ARC REVIEW CODE: R2001151

Name of Proposal: Oakmont Cobb International (DRI #3032)

Description: A Development of Regional Impact (DRI) review for a proposed 639,292 SF warehouse/distribution center in the City of Kennesaw. The 46.7-acre site is located east of Cobb International Boulevard and north of Stanley Road. The main entrance on Cobb International Boulevard will be the only access for trucks. An additional access point on Stanley Road will allow access for personal vehicles. Gross daily trip generation is estimated at 1,056 trips, including 206 truck trips. The local trigger action is a proposed rezoning from R-20 Residential to LI Light Industrial. Full buildout is planned for 1Q 2021.

DRI SITE PLAN

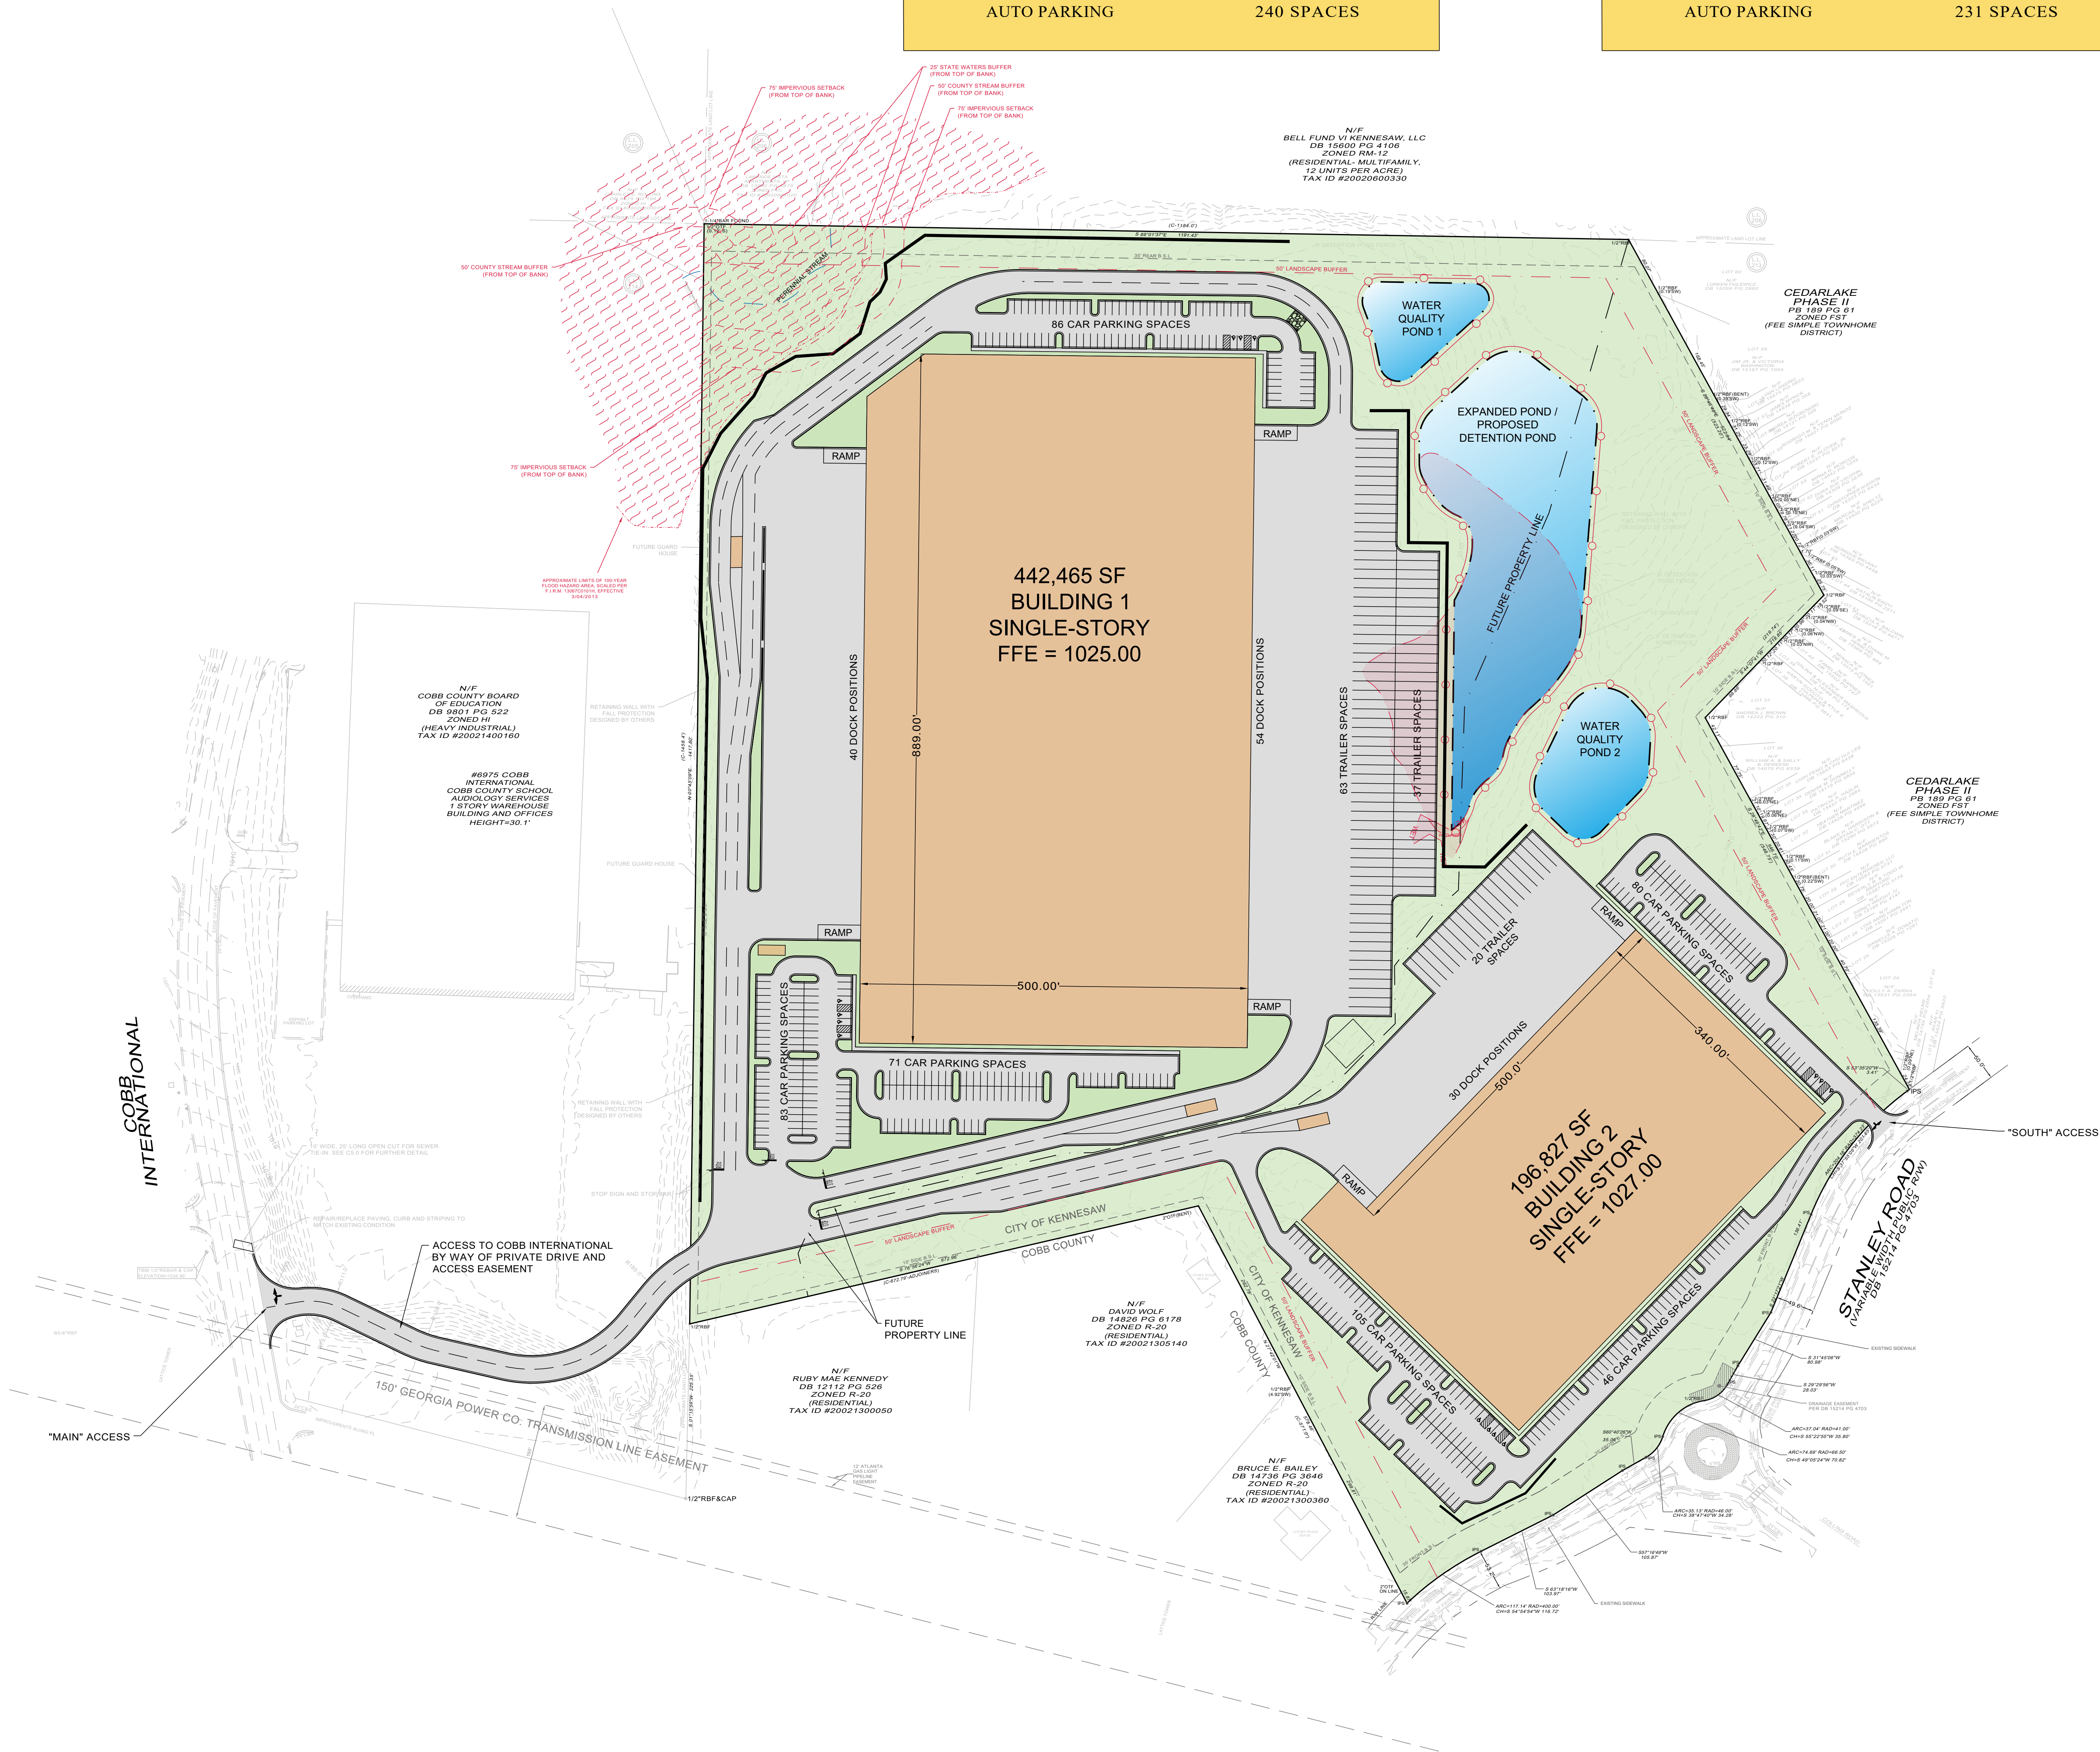
The project can further support The Atlanta Region's Plan in general by incorporating other aspects of regional policy, including green infrastructure and/or low-impact design best practices throughout the site in general, in parking areas, on site driveways, in stormwater detention facilities, and as part of any improvements to site frontages. In addition, ARC encourages the applicant team to ensure that the development promotes a functional, safe, clearly marked and comfortable pedestrian experience on all proposed driveways, paths and parking areas on the site, including the driveway on Stanley Road. It should be accessible for pedestrians, even if access is controlled.

A future consideration for the primary driveway on Cobb International Boulevard is the potential route for a pedestrian/bike trail using portions of the utility easement along the southern border of the DRI and along Cobb International Boulevard. The location and design of the driveway should not preclude integration with a future trail crossing if needed.

The DRI's site design should provide sufficient truck parking to prevent trucks from queuing or waiting on any adjacent or nearby roads. Trucks parking in and along public roadways – typically while waiting for an available dock at a nearby facility – is an identified issue in many areas of the region that negatively impacts roadway operations, safety and congestion. Signage and other measures to ensure drivers use the appropriate freight routes should be emphasized.

In consideration of the current MDR FLU and R-20 zoning in the unincorporated island abutting to the southwest of the Oakmont Cobb International site, without augmentation the 50 foot wide buffer along the shared boundary may be insufficient for protecting existing and future residential development. In past DRI comments relating to distribution / warehouse developments of this scale, Cobb County has requested consideration of standards that would work to maintain quality of life in abutting residential areas. For this specific proposed development, the following are encouraged to be considered in the site plan review process:

- With deference to the surrounding parcels, the (proposed/required?) 50' landscape buffer should be enhanced with supplemental evergreen plant material. This material should be a mix of broad-leaf and needle-leaf trees and shrubs. This material, in conjunction with the existing vegetation along the periphery of the site, would shield the view of the facility from existing and future residents and help attenuate potential noise and light pollution. The supplemental planting plan should be reviewed by the city prior to the issuance of a land disturbance permit.

- The extensive existing tree stand and undergrowth on this site provide significant air/water quality, soil stabilization and storm flow mitigation benefits for this watershed. Construction of this project will eliminate the vast majority of this vegetation and increase impervious surface coverage, storm runoff and non-point source pollution. The proposed

impervious coverage for this project is significantly greater than what the current zoning category would allow. To compensate, the First Flush Water Quality Best Management Practice Requirements should be elevated to the 1.5-inch rainfall event and each larger storm discharge controlled not to exceed the allowable discharge of the next lower, more frequent storm event (i.e. 5-year storm event released at 2-year rate; 10-year event at 5-year rate; etc. to 100-year event at 50-year rate).

The USGS coverage for the project area shows no blue-line streams on the project property, but the project site plan shows a perennial stream in the northwestern corner of the project property. The State 25-foot sediment and erosion buffer and the City 50-foot stream buffer and 75-foot impervious setback are shown. A retaining wall is shown intruding on the 75-foot setback, with no other development shown within the buffers. Any intrusions into the City buffers may require a variance from the City. Any unmapped waters of the State on the property will be subject to the requirements of the State 25-foot sediment and erosion buffer.

The site plan identifies two (2) proposed driveway access points: one on Stanley Road and one on Cobb International Blvd.

Sidewalk currently exist along Stanley Road however sidewalk facilities along Cobb International are incomplete adjacent to the proposed development site.

The development offers one access point for freight traffic and one for private vehicle traffic.
